**Work Order ID 113908**

**Item Name:** Bracket

## WORK ORDER NON-CONFORMANCE / UPDATE

**D4541-2 BRACKET**

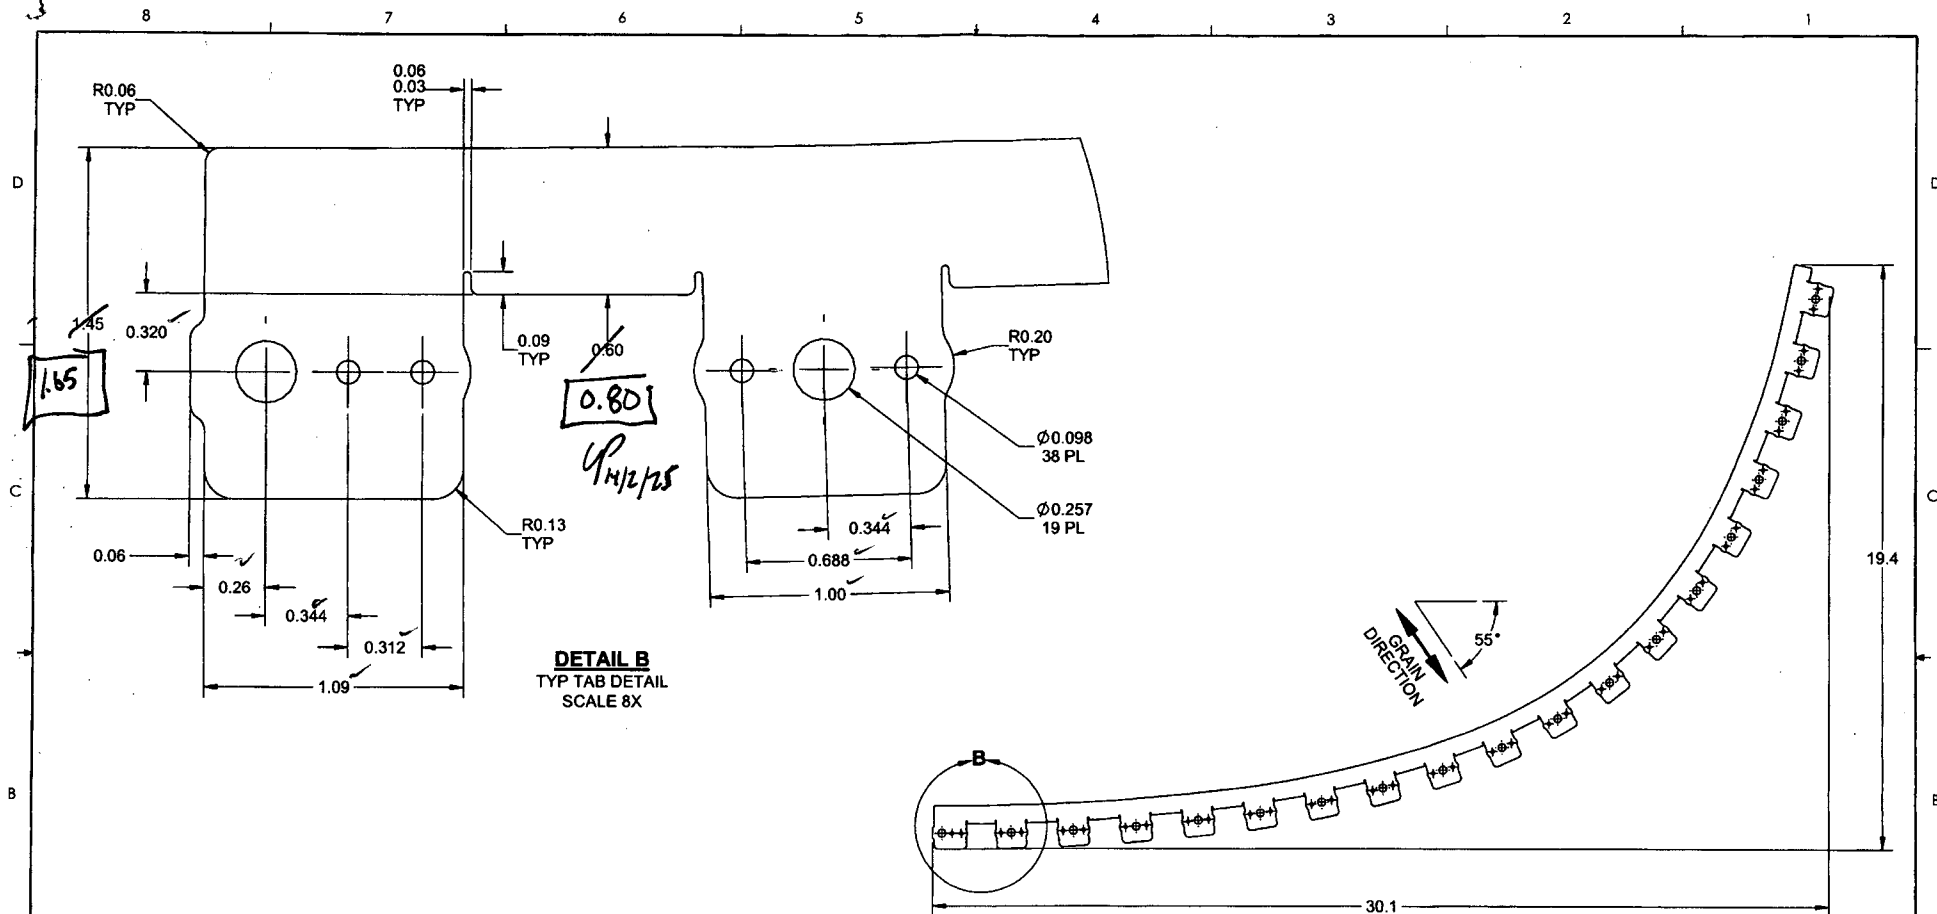
Root Cause	Date	Step	Qty	Description of work order update or non-conformance	Initial Chief Eng	Action Description	Sign & Date	Verification	QC Inspector
Design	14/2/25	100	2	CUSTOMER NEEDS CUSTOM PART TO FIT HIS AIRCRAFT.	DAS 12 9-89  14/2/25	BASE OF PART IS 0.200 WIDER TO ENSURE PROPER HOLE EDGE DISTANCE	DAS 12 9-89  14/2/25	DAS 27 9-89  14/2/27	D 2 9-89  14/2/27
Doc/Data									
Equip/Tooling									
Handling/Pre									
Material									
Operator									
Offset/Setup									
Process									
Supplier									
Training									
Transport									
Unapproved
